JLG 13070B-5A Construct New IT Center

St Cloud VAHCS Proj. No. 656-14-246

RE: Amendment No. 4

## Amendment No.4 (05.12.2016)

1 FIRST FLOOR DEMOLITION PLAN  
SCALE: 1/8" = 1'-0"

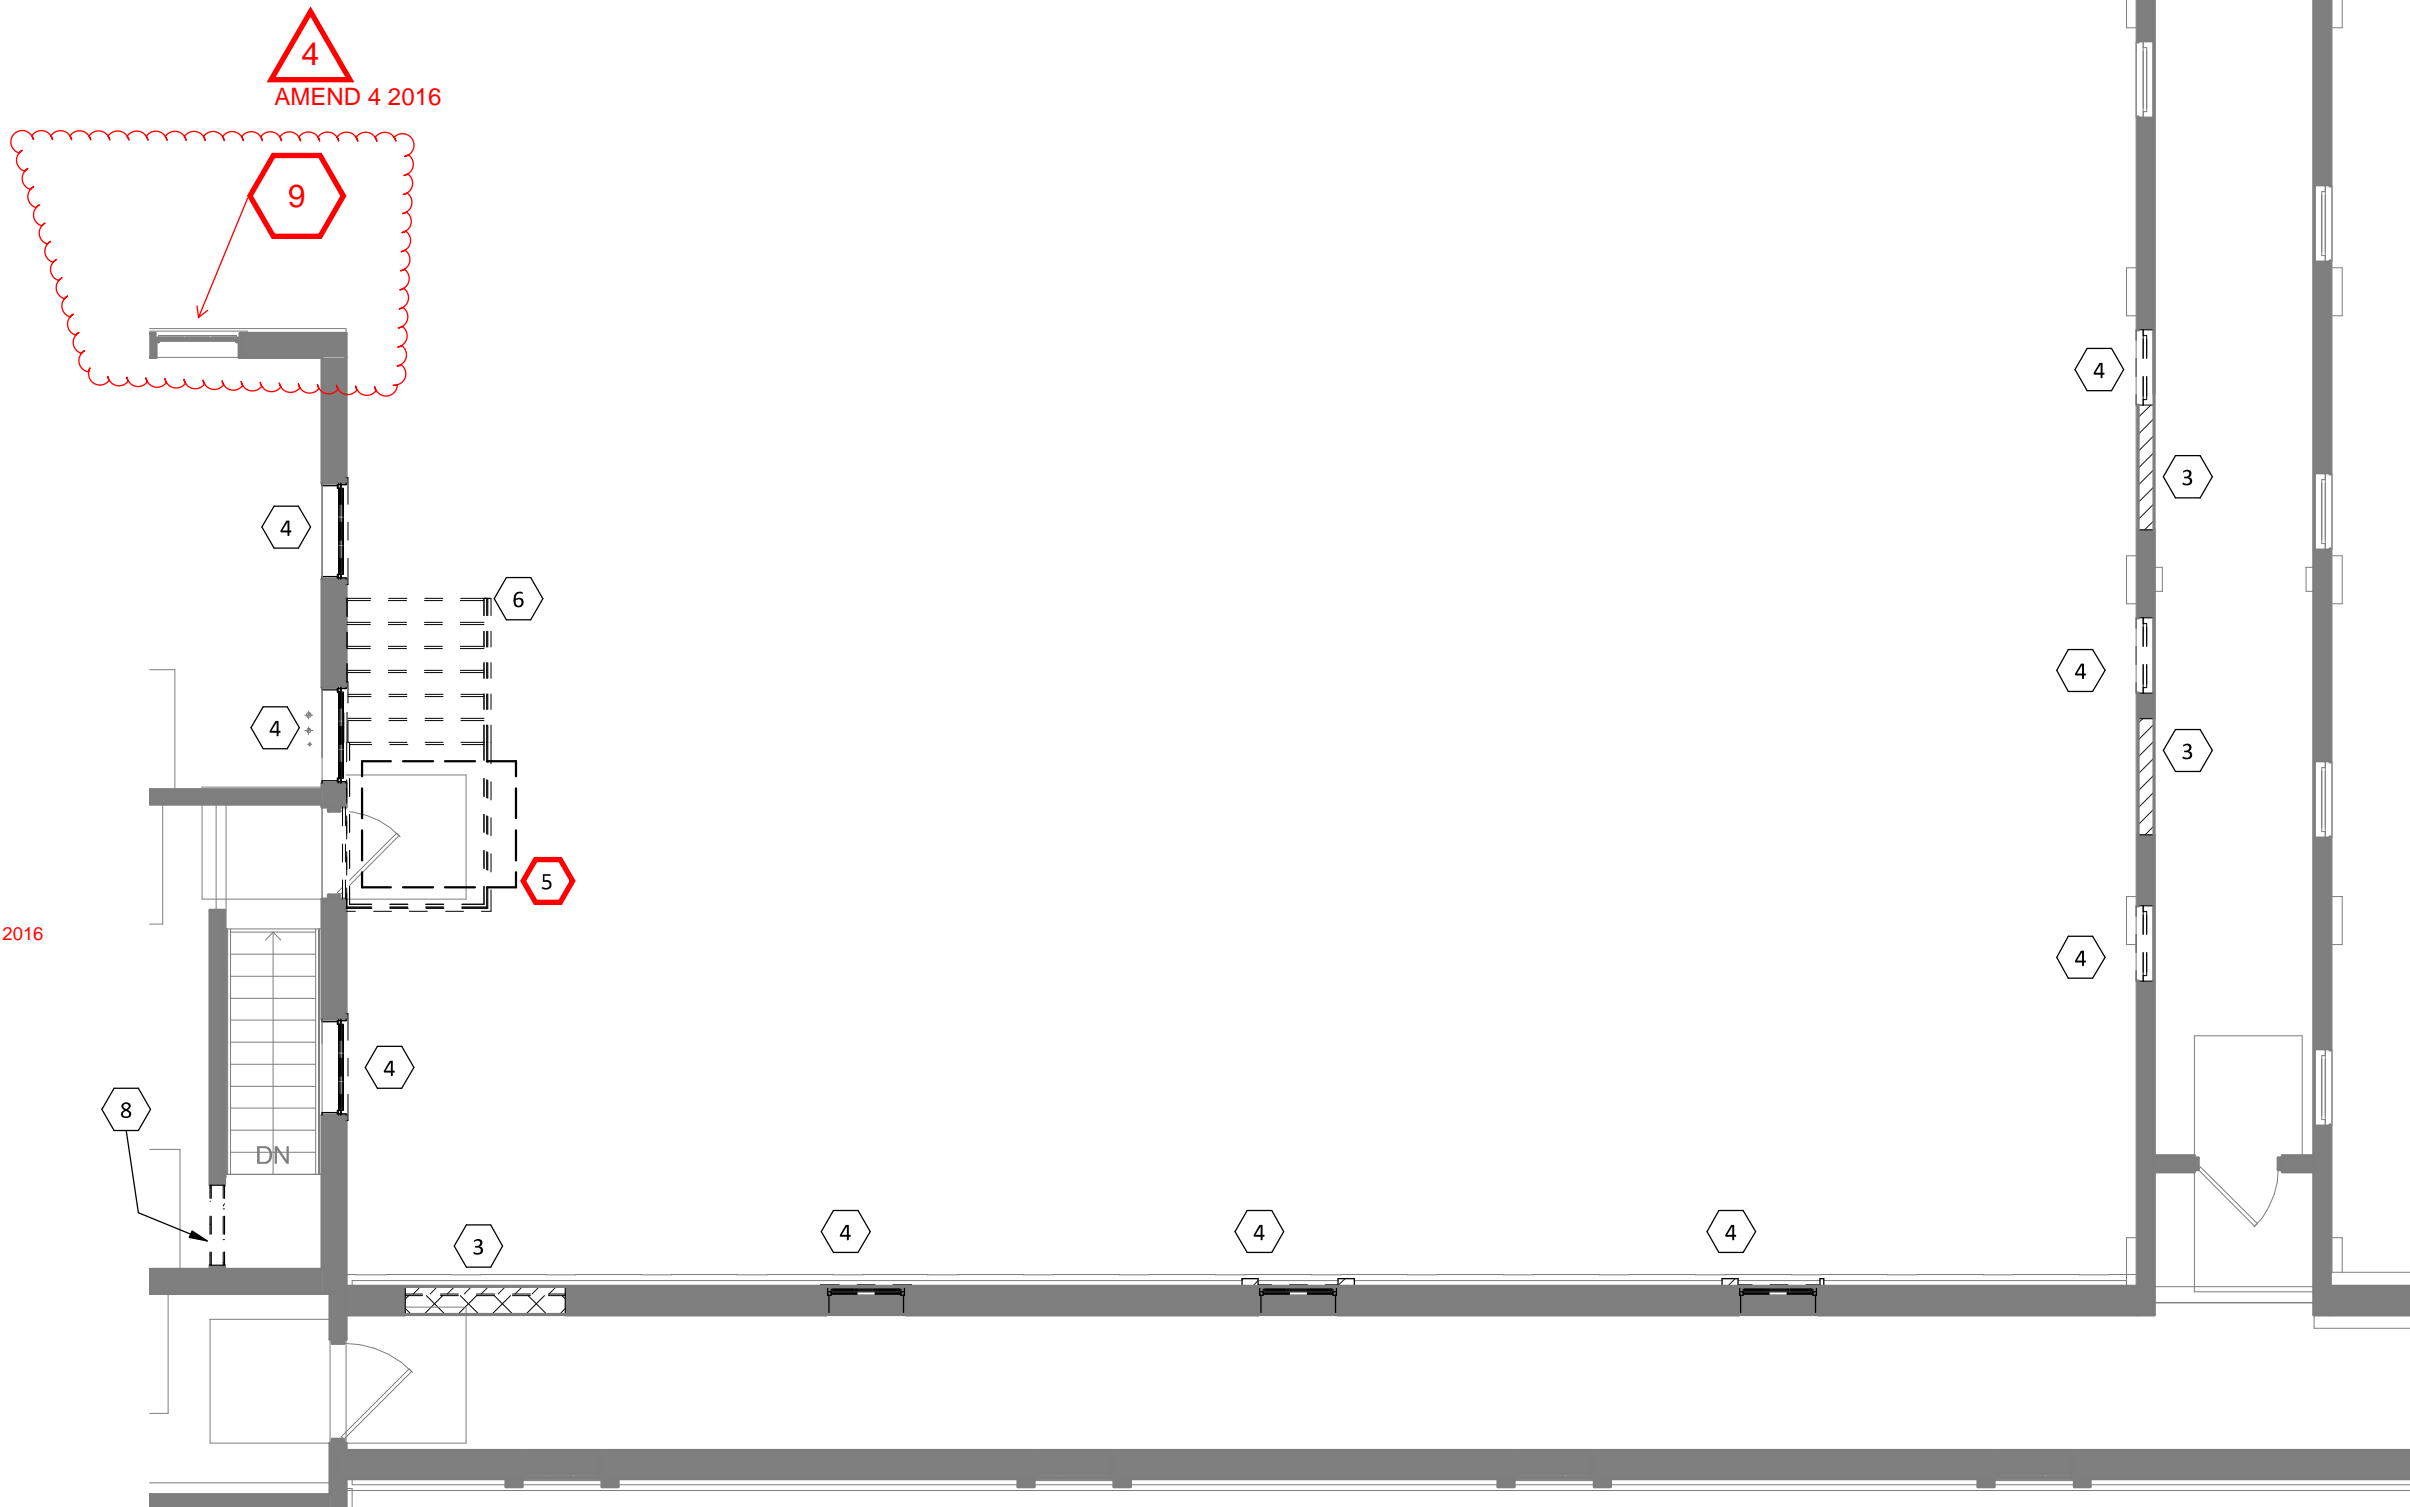
- A101 Replace Demo Plan 1/A101 with drawing 1/A101rev. Update demolition Keynotes on sheet A101, with those found on drawing 1/A101rev.

9. REMOVE & SALVAGE WINDOW SASH FOR RE-USE. INSTALL METAL STUD INFILL FRAMING & EXTERIOR SHEATHING IN OPENING. COORDINATE DUCT PENETRATIONS W/ MECHANICAL. REMOVE INFILL AND REPLACE SASH FOLLOWING INSTALL OF NEW AHU-4. SEE MECHANICAL.

DRAWING NO.  
E401

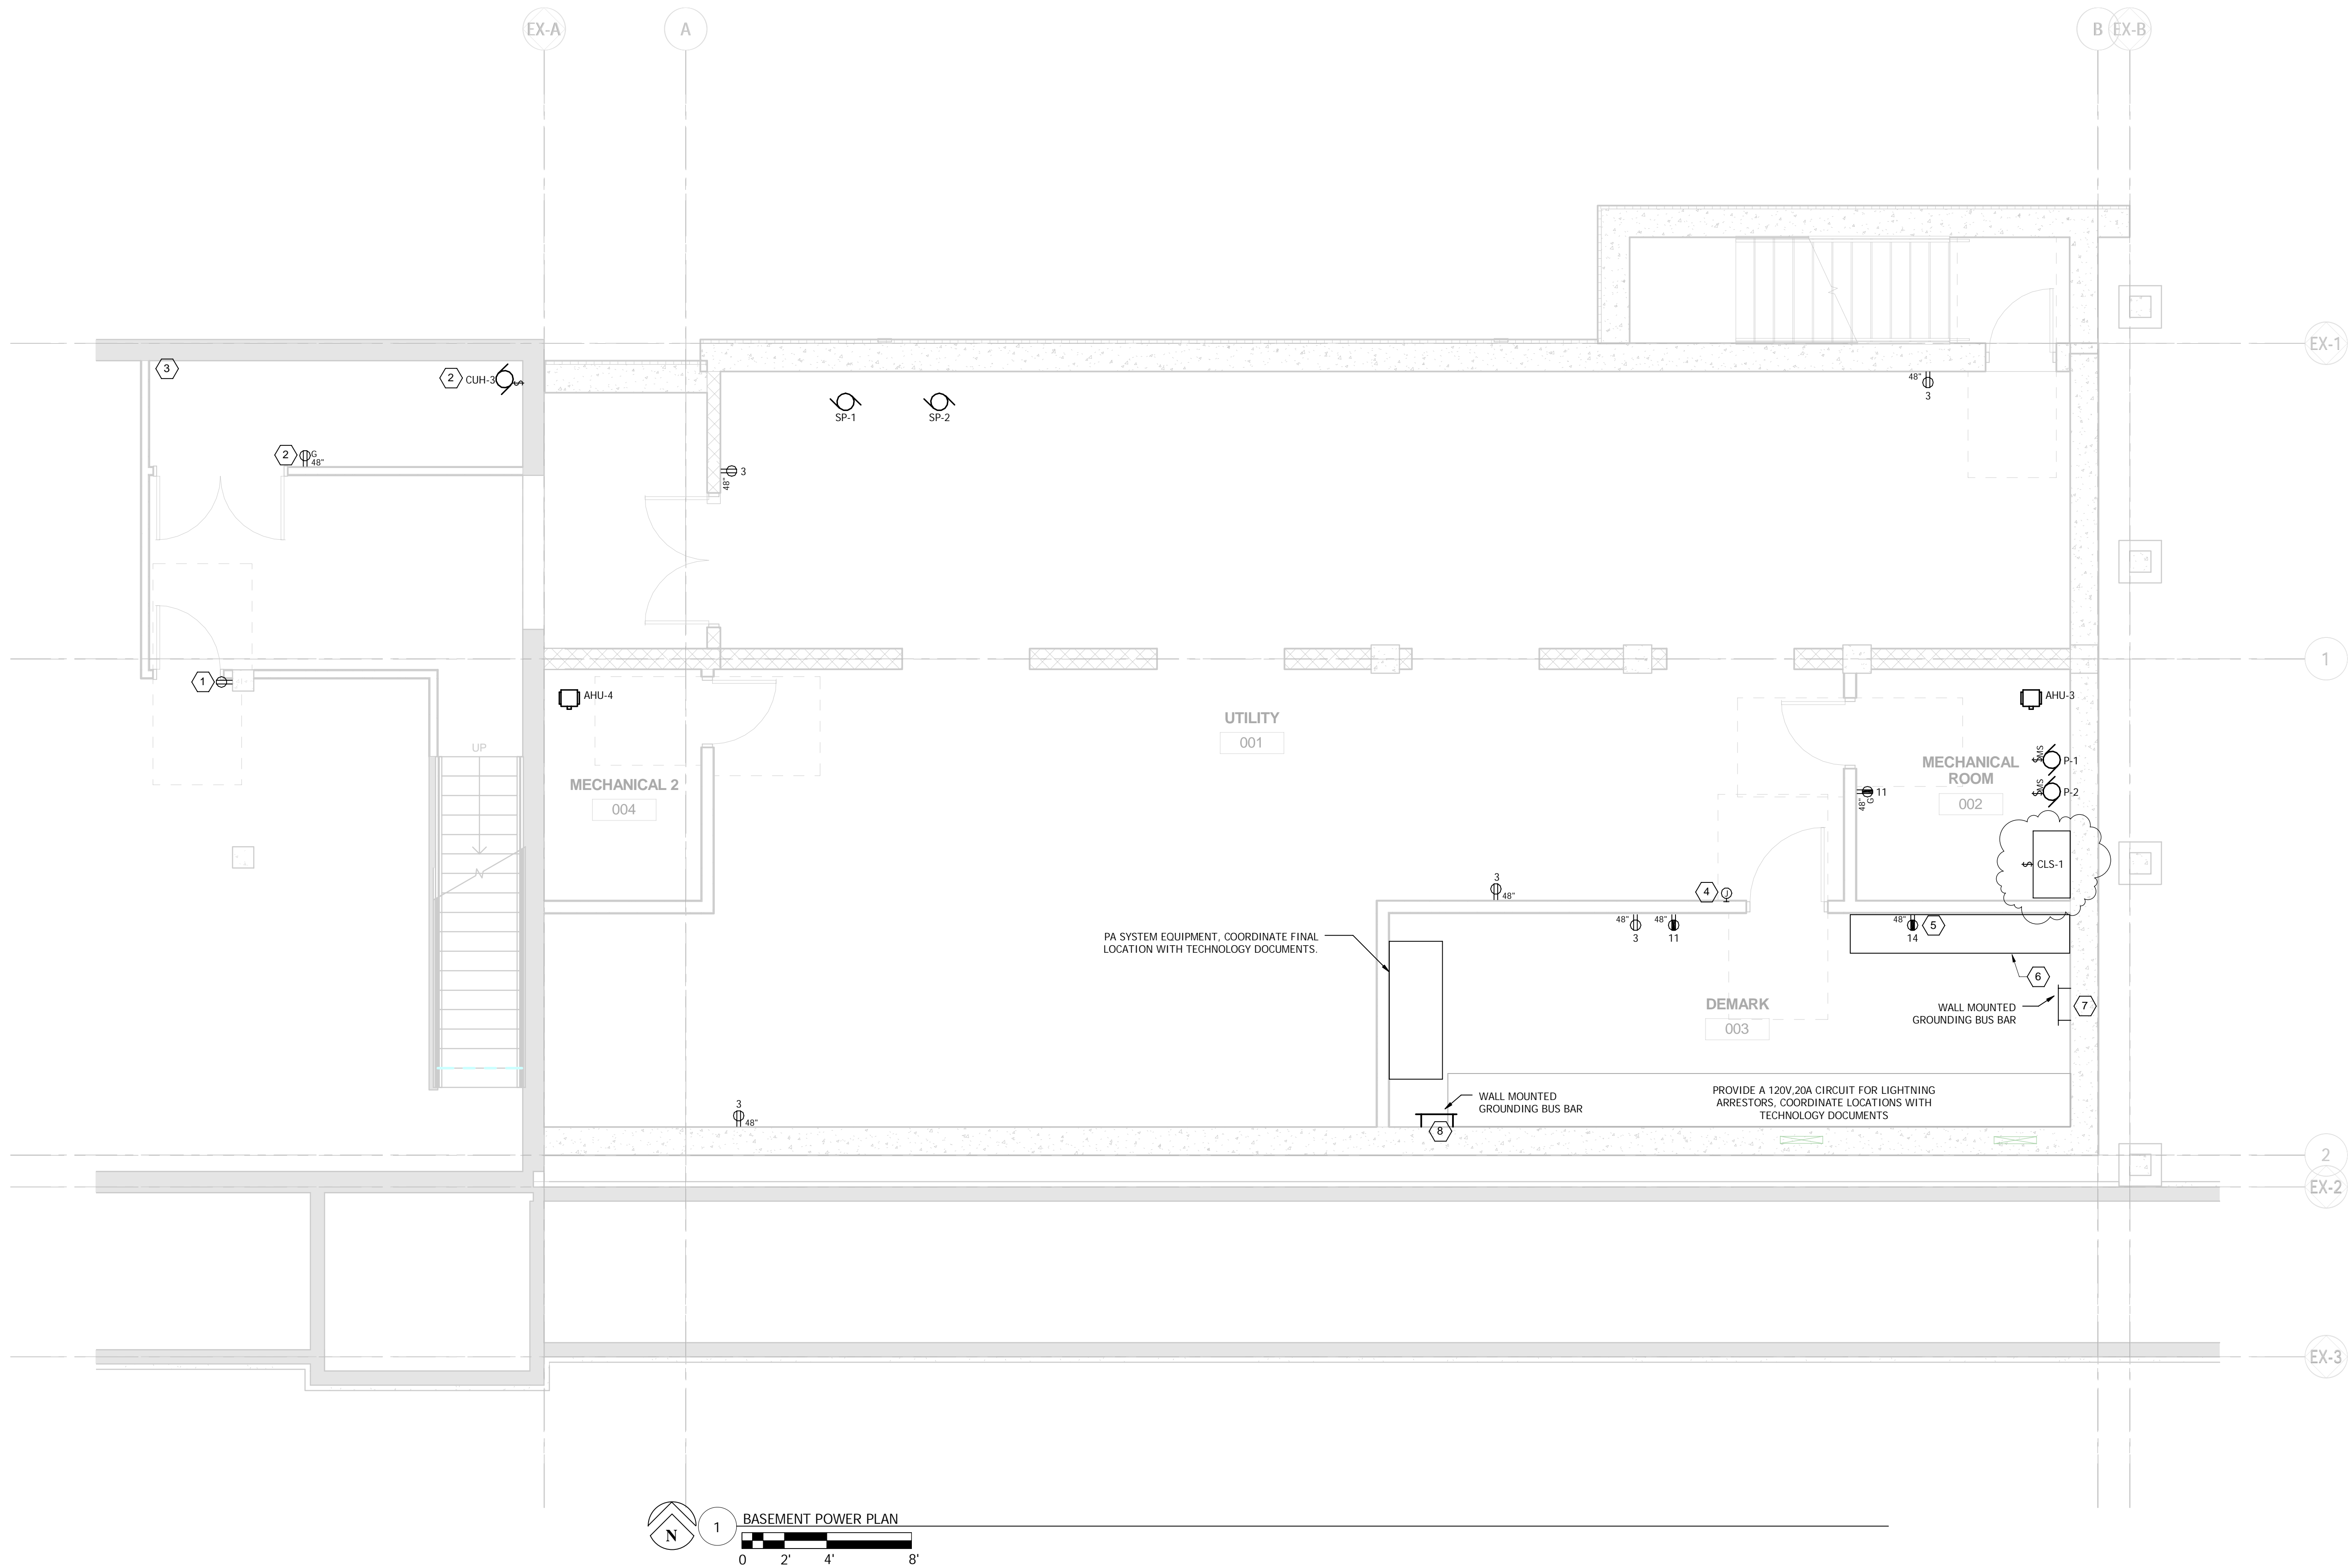
7. Add the condensation lift station in the basement mechanical room shown on attached drawing E401.
8. Relocate the existing building 4 conference room split system condensing unit shown on attached drawing E402.

5. EXISTING CONDENSING UNIT TO BE RELOCATED TO LOCATION SHOWN WEST OF GRID LINE EX-A. RELOCATE ELECTRICAL FEED TO NEW LOCATION. REMOVE ALL ABANDONED ELECTRICAL.
